World Forum for Harmonization of Vehicle Regulations**Working Party on Passive Safety****Fifty-sixth session**

**Global technical regulation No.9 (Pedestrian safety) – Proposal for
Phase 2 of the global technical regulation****Proposal for amendments to global technical regulation No. 9
(Pedestrian safety)****Submitted by the expert from the European Commission as Chair of
the Task Force on Bumper Test Area within the Informal Working
Group on global technical regulation No. 9 Phase 2***

Part B, Text of the Regulation,

Figure 5, amend to read:

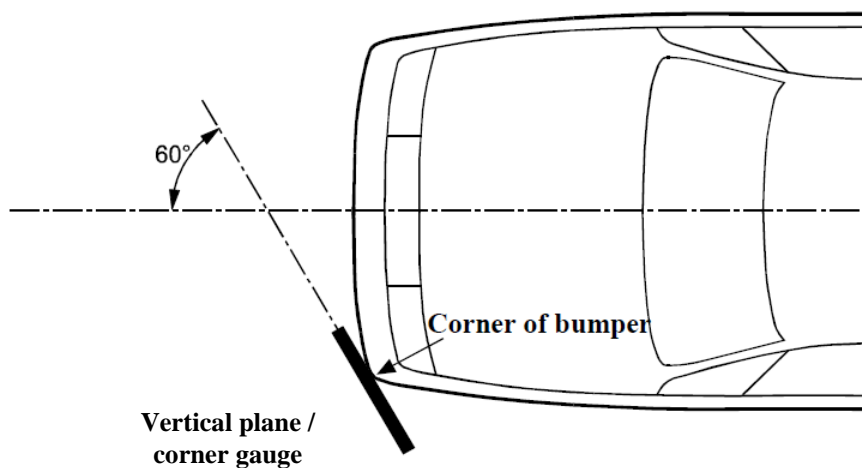
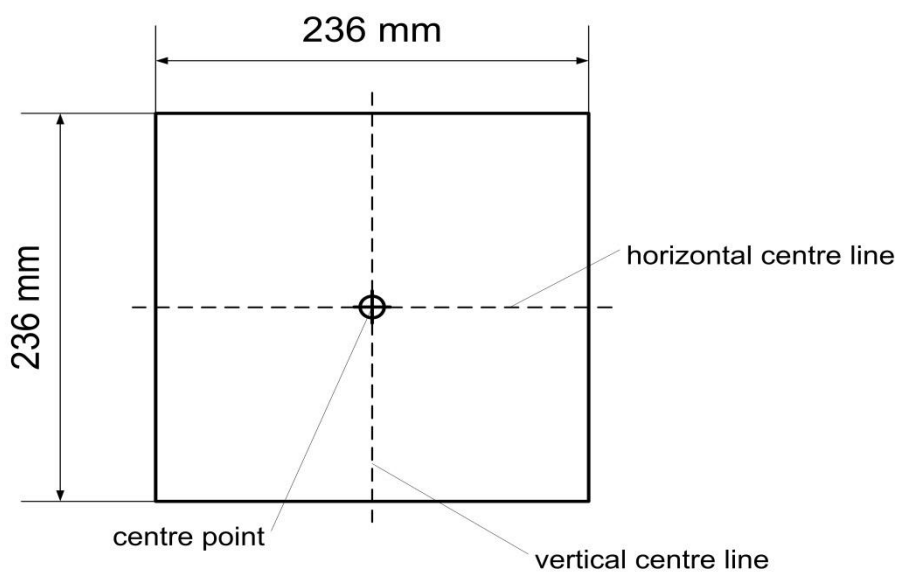
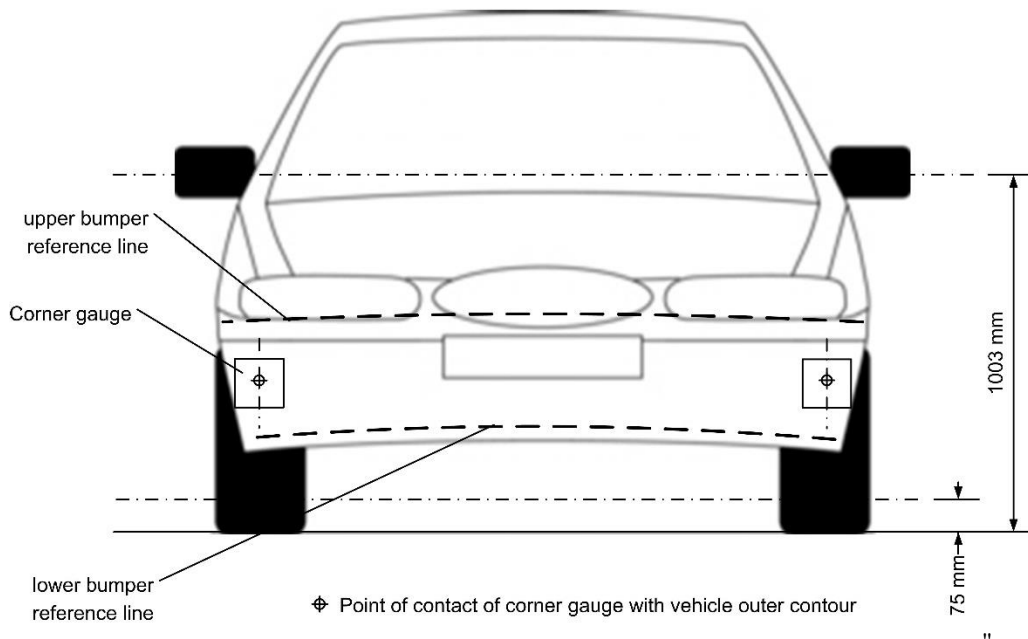
"3.13. **"Corner of bumper"** means **the transversal position of the vehicle's point of contact with a vertical plane which makes an angle of 60° with the vertical longitudinal plane of the car and is tangential to the outer surface of the bumper (see Figure 5).corner gauge as defined in Figure 5B.**

For determination of the corner of bumper, the front surface of the corner gauge is moved parallel to a vertical plane with an angle of 60° to the vertical longitudinal centre plane of the vehicle (see Figures 5A and 5C) at any height of the centre point of the corner gauge in the following area:

- (a) **Equal to and above the point found on the vertical line intersecting the Lower Bumper Reference Line at the assessment position in transversal direction or at 75 mm above the ground reference plane, whichever is higher.**
- (b) **Equal to and below the point found on the vertical line intersecting the Upper Bumper Reference Line at the assessment position in transversal direction or at 1,003 mm above the ground reference plane, whichever is lower.**

For determination of the corner of bumper, the gauge is moved to contact the outer contour/front fascia of the vehicle touching at the vertical centre line of the gauge. The horizontal centre line of the gauge is kept parallel to the ground plane.

The corners of bumper on both sides are subsequently defined as the outermost points of contact of the gauge with the outer contour/front fascia of the vehicle as determined in accordance with this procedure. Any points of contact on the top and the bottom edges of the gauge are not taken into account. The rear and side view mirrors and the tyres shall not be considered."
